# Service Bulletin

Bulletin No.: 22-NA-248

**Subject: HVAC Heat Intermittently Inoperative, DTCs B2B05 and/or B2B06 Set**

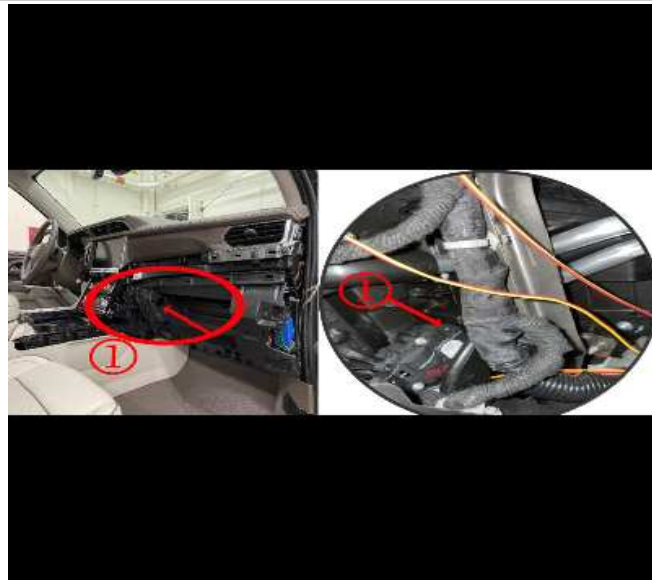
Visually inspect the right side temperature valve actuator (1) and the left side temperature valve actuator (2) for a yellow dot, as shown in the pictures above, that indicates the parts were manually re-flashed. If the yellow dot is present, replace the temperature valve actuator.

Refer to *Temperature Valve Actuator Replacement* in SI.
